December 5, 2014

Re: The City of Benicia's Draft Environmental Impact Report for the Valero Benicia Crude by Rail Project

Figure 1. Twelve Salt Marsh Harvest Mouse Conservation Areas in Suisun Marsh.

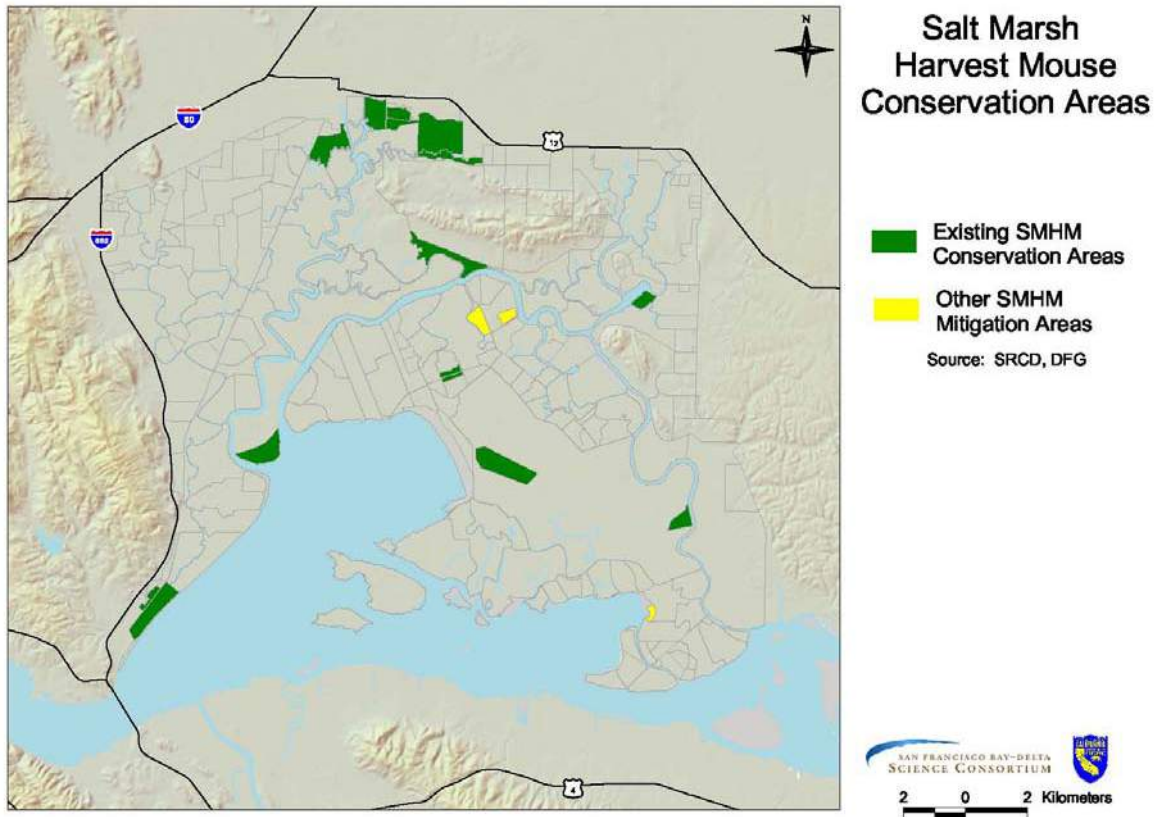
This is especially troubling given that one of the twelve Salt Marsh Harvest Mouse Conservation Areas in the Suisun Marsh is directly adjacent to the Project area. *See* Figure 1. Furthermore, the salt marsh harvest mouse, California clapper rail, and California black rail are State Fully Protected Species which means that no take or permits for take are allowed.<sup>2</sup>

Figure 2. Union Pacific Railroad Crude-By-Rail Routes.  
 Source: <http://www.up.com/customers/chemical/crude/index.htm>

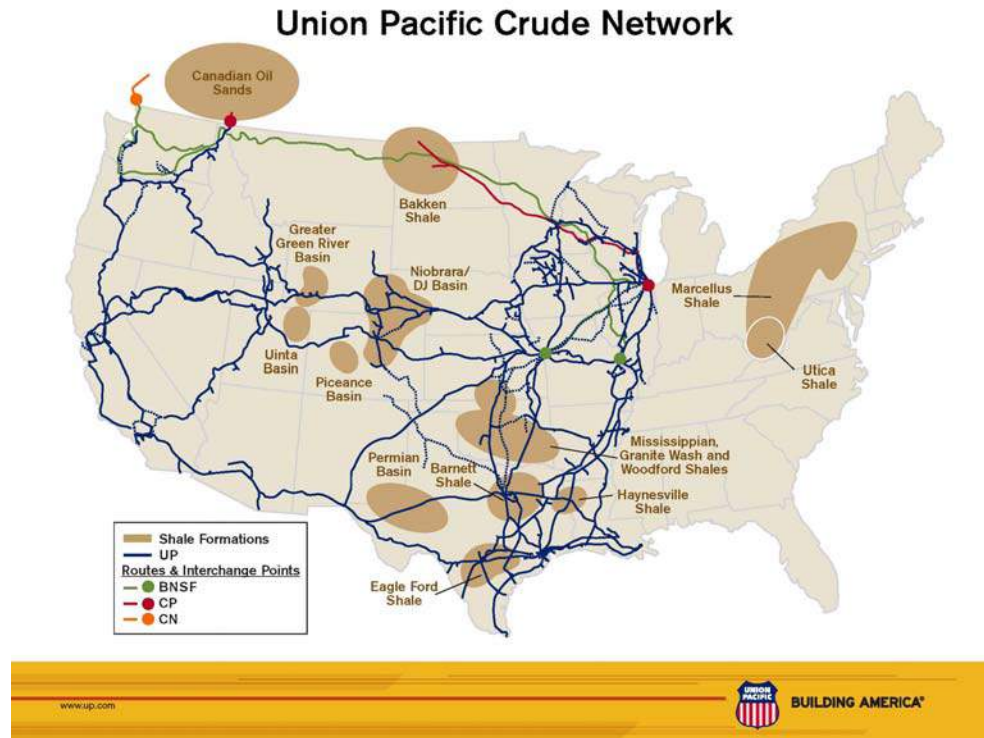
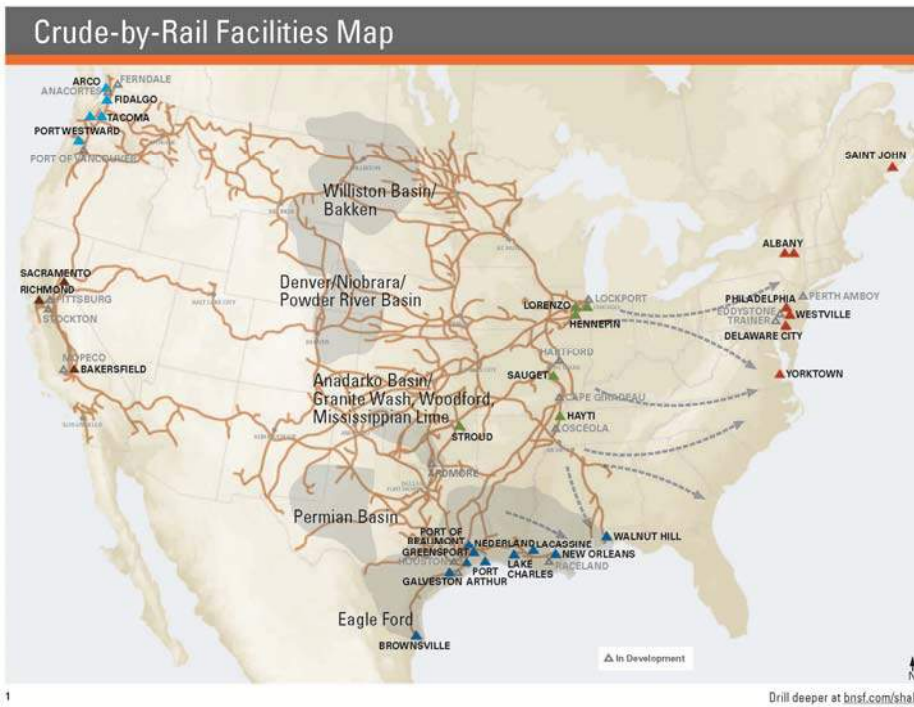
Because only a handful of rail lines would serve the Project, the analysis of the potential impacts to special-status species along these lines is eminently feasible. Within California and many western states, for example, very few branches of Union Pacific and BNSF rail lines lead to Roseville. *See* Figures 2 and 3.

Figure 4. Critical habitat for threatened and endangered species bisected by UPRR track with ownership rights in the San Francisco Bay Area in California.

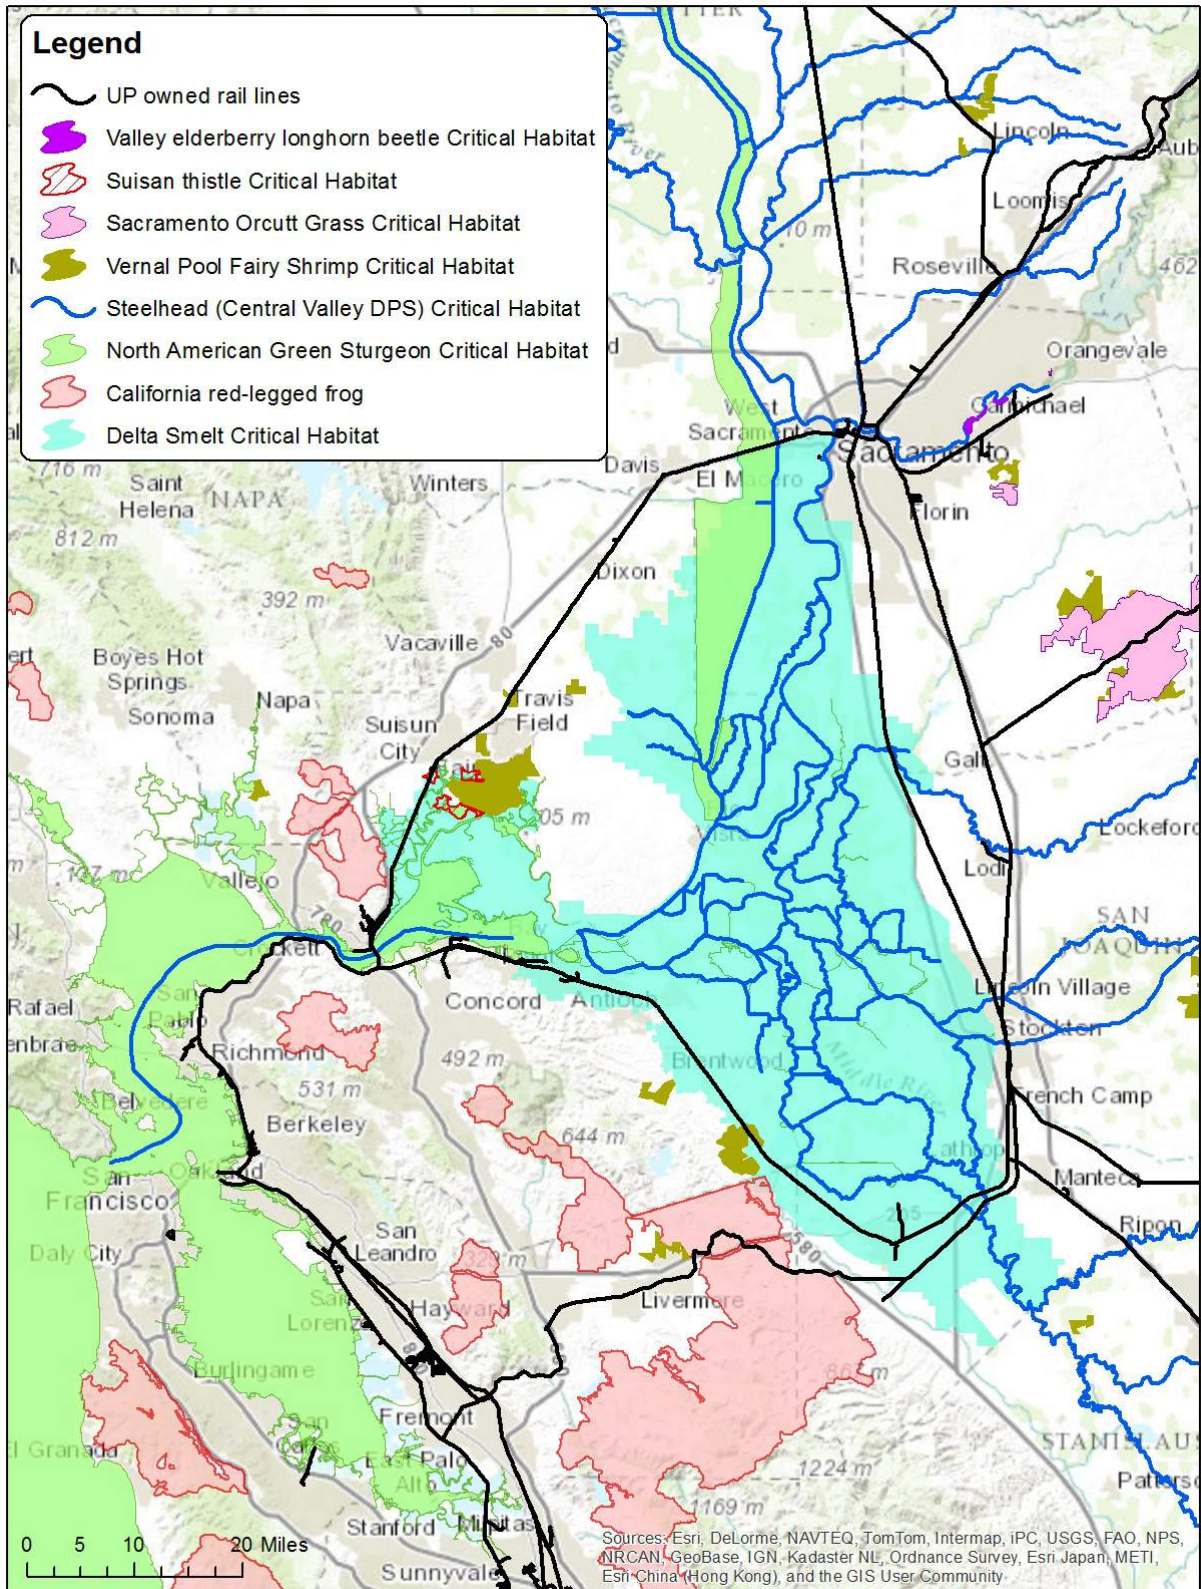
Union Pacific Railroad (UPRR) rail lines cut through critical habitat for many threatened and endangered species along the mainline rail network. In California alone, UPRR track with UPRR ownership rights pass directly through critical habitat for 25 federally protected species, including terrestrial and aquatic animals and plants. *See* Table 1 and Figure 4. The Project would enable the rail transport and processing of Bakken and Canadian tar sands crude oil to the refinery. As shown by the maps of UPRR and BNSF crude-by-rail routes (i.e., Figures 2 and 3), the rail lines transporting crude oil from the Bakken shale deposit on the North Dakota-Montana border would pass through occupied habitat for many threatened and endangered species, such as the grizzly bear in the Northern Continental Divide Ecosystem (NCDE) in northwest Montana. The DEIR's failure to disclose and analyze these impacts to special-status species and sensitive habitats along the rail lines violates CEQA.
